Access Compliance Report

Public Rights-of-Way

(Curb Ramps)

Intersection ID: 10024493	Main Street: CROWNPOINT_EXECUTIVE_DR	Cross Street: N/A	Location: W
ADA ID: 17EB0E8B7387	Ramp Type: PerpDiag	Initial Pass/Fail: Fail	Overall Compliance: No
Severity Score: 8.75			
Codes/Mitigation Info/Possible Solution		Field Measurements/Component Compliance

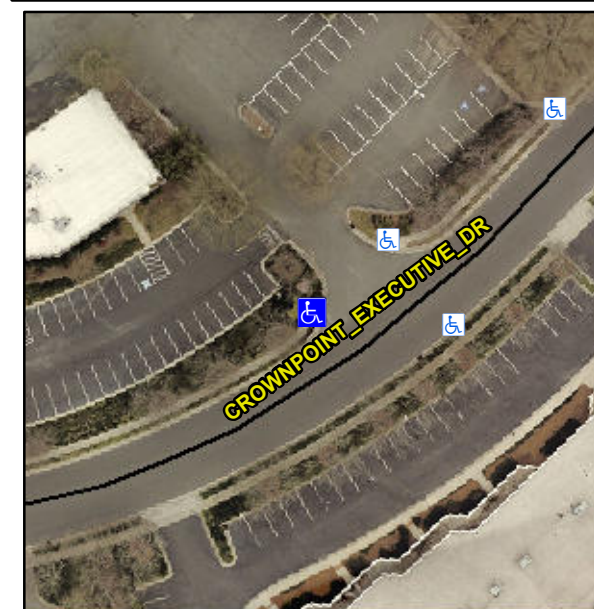
Not Found, R304.5.1

Compliance	Description	Data	Compliance	Description	Data
N/A	Ramp Length (in)	35.0	Yes	Ramp Slope (%)	6.5
No	Ramp Width (in)	46.5	Yes	Ramp XSlope (%)	0.8
N/A	Flare Type LT	N/A	N/A	Flare Type RT	N/A
N/A	Flare Slope LT (%)	N/A	N/A	Flare Slope RT (%)	N/A
N/A	Flare Traversable LT?	N/A	N/A	Flare Traversable RT?	N/A
N/A	Landing Length (in)	N/A	N/A	DWS Provided?	N/A
N/A	Landing Width (in)	N/A	N/A	DWS Contrast?	N/A
N/A	Landing Slope (%)	N/A	N/A	DWS Length (in)	N/A
N/A	Landing X Slope (%)	N/A	N/A	DWS Full Width?	N/A
N/A	Landing Curb? (Y/N)	N/A	N/A	DWS Offset (in)	N/A
N/A	Shared Landing?	N/A			
N/A	Gutter Ponding?	N/A	N/A	Gutter Slope (%)	N/A
N/A	Gutter Lip Ht (in)	N/A	N/A	Gutter X Slope (%)	N/A
N/A	Painted X Walk1?	No	N/A	Painted X Walk2?	No
	X Walk 1 Direction	To SE		X Walk 2 Direction	To NE
N/A	X Walk 1 Width (in)	N/A	N/A	X Walk 2 Width (in)	N/A
	X Walk 1 Slope (%)	3.3		X Walk 2 Slope (%)	6.4
	X Walk 1 X Slope (%)	3.1		X Walk 2 X Slope (%)	0.2

Remove & Replace Curb Ramp With Two New Directional Ramps or Equivalent.
